Florence County Government

ADDENDUM NO. 1- FRIENDFIELD FIRE STATION (BID NO. 2-16/17)

Florence County is sending to all interested firms clarification information and answers to questions concerning this Invitation to Bid. The answers are highlighted in blue and underlined. Please include this sheet with your proposal.

Monarch Series - ICC
Internal Cam Cleat
Rope Halyard
Ground Set Installation

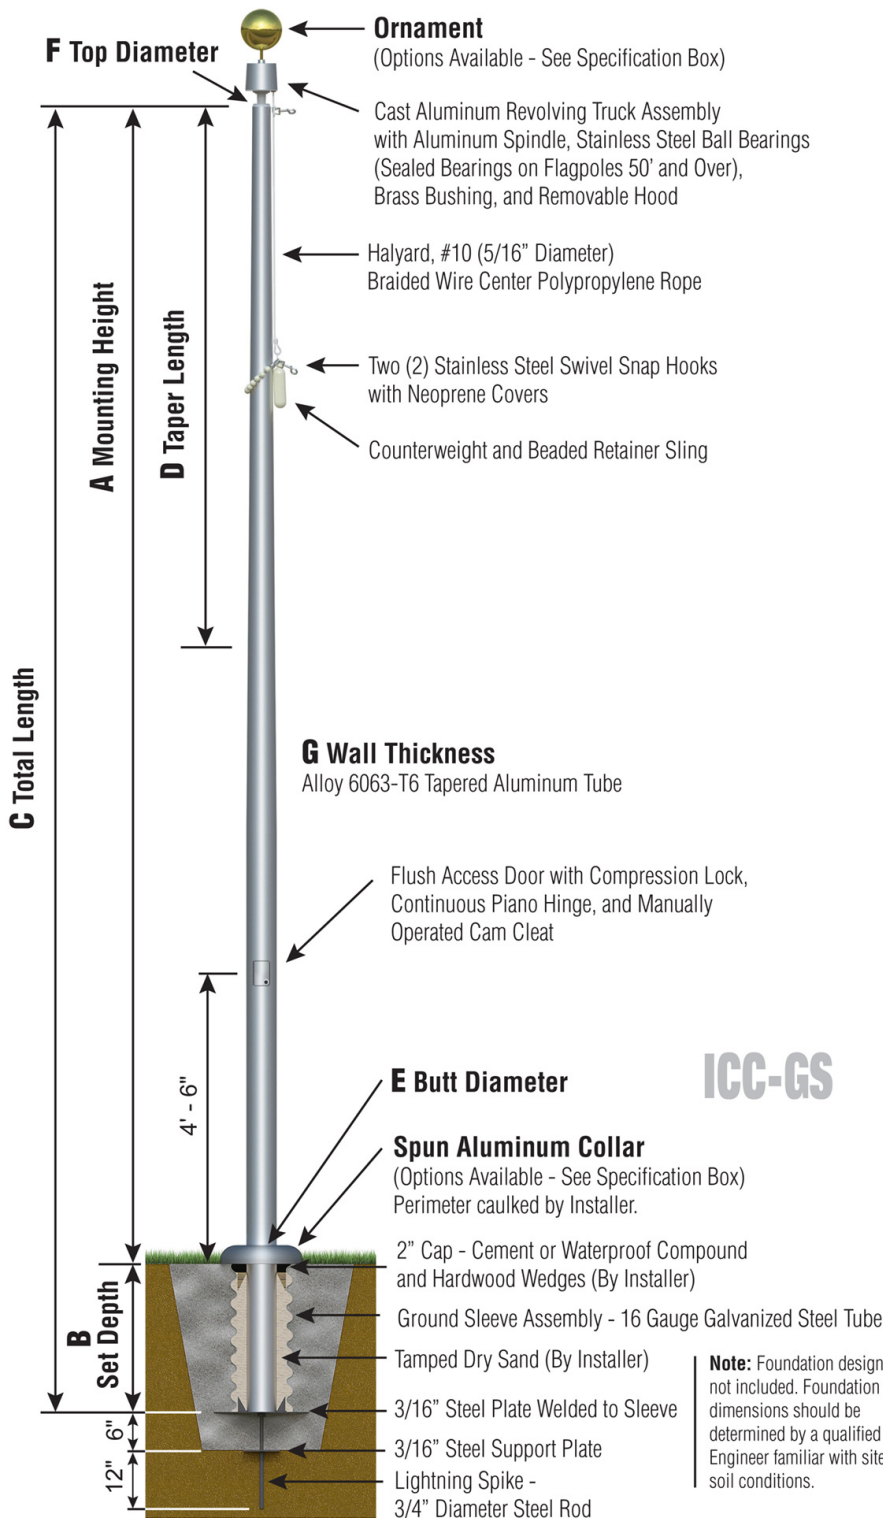
2. What is the height of the flagpole? The flagpole is a one-piece, 33 foot pole. Specifications are attached.
3. Is 120 days correct for the fill build-out time? We are aware that it takes at least 8 weeks (60 days) for the building to arrive after the initial order, and have extended the time to 9 months (270 days).
